August 28, 2006

Regarding: Float Dock Permit #SE79-243

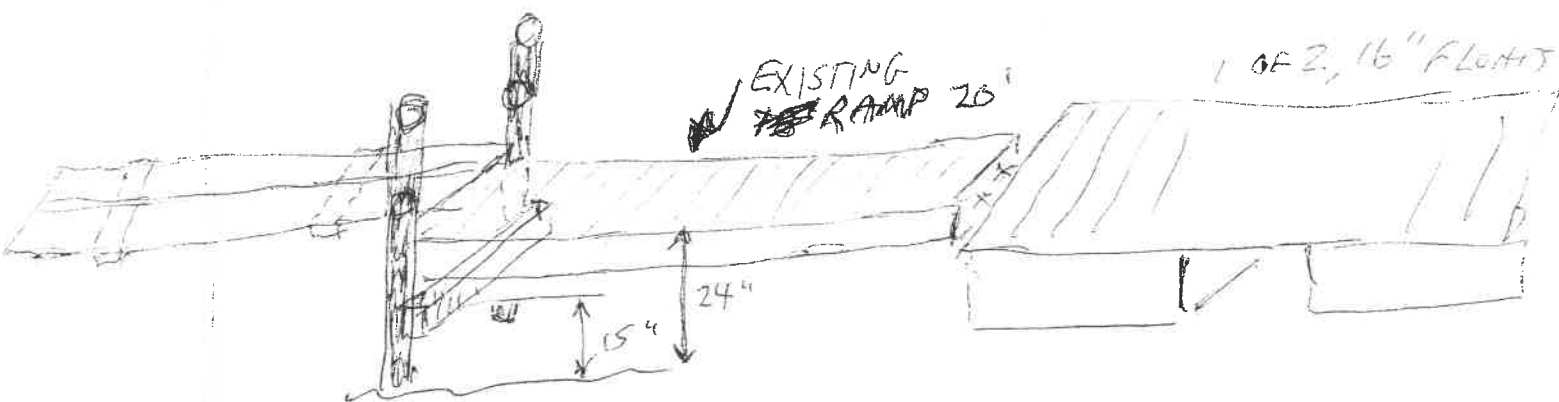
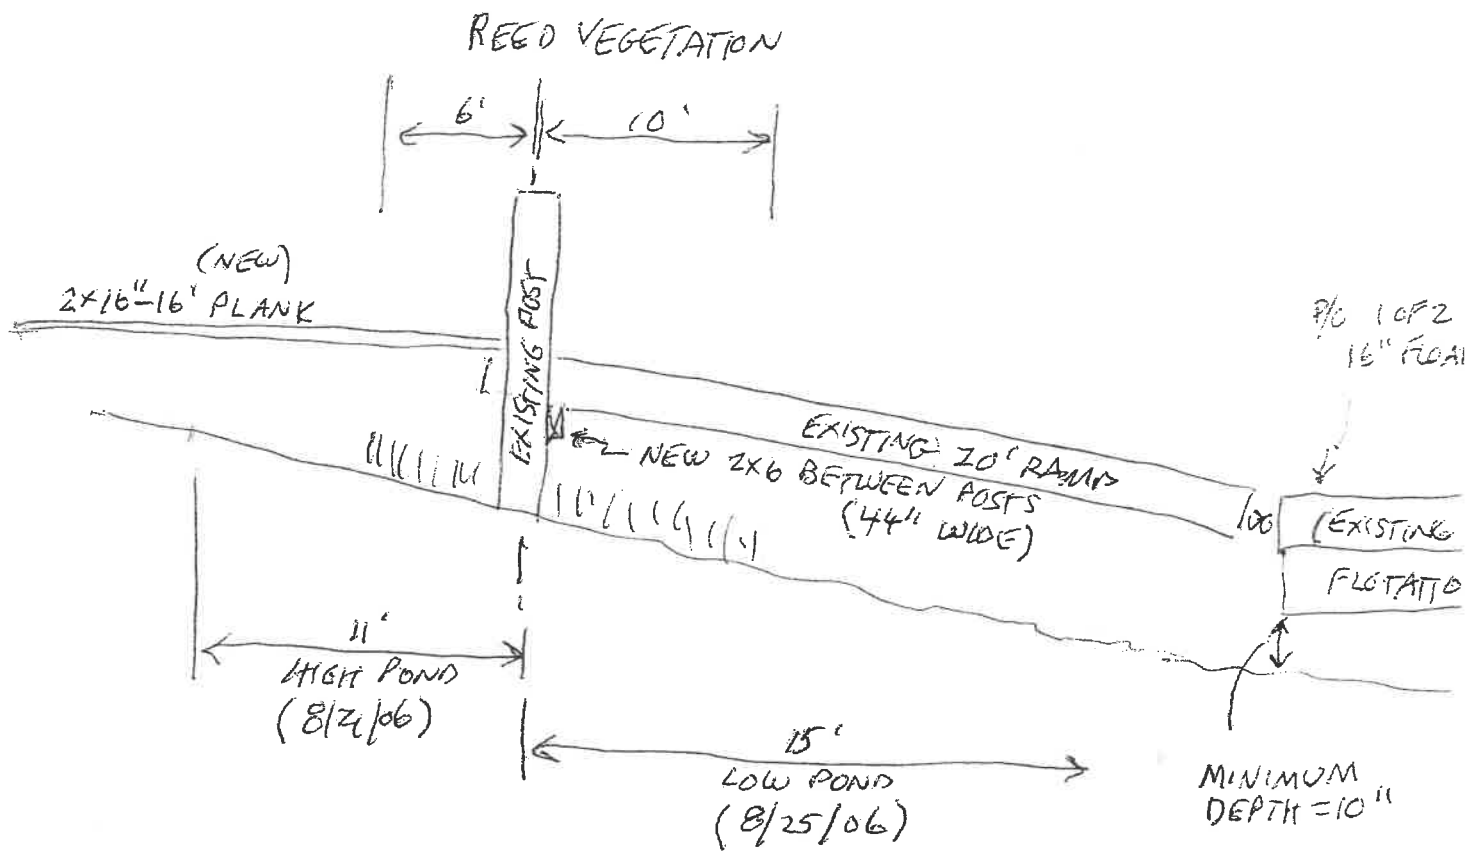
During the time it was in place in 2005, the pond remained lower than its recent high level. We had no problem walking from the path to the ramp. The ramp was built 20' long. It was realized that only two 16' floating sections were needed and therefore the third section, as shown on the application plan, was not built. By making the ramp 20' long, we avoided the problem of the inshore float bottoming out at low pond.

This year, the pond height has been very high for most of the summer. Before being opened this week, it was at its highest level so that the ramp was underwater at the inshore end.

What has been proposed is to raise the inshore height of the ramp 15" as shown on the attached plan. The ramp would be supported by a 2x6 fastened between the two existing posts. After the ramp is raised a 16" wide walkon plank (two, 2x8's spaced 1" apart), 16' long would be used to go from the ramp to the inshore edge of the bank in the middle of the approach path.
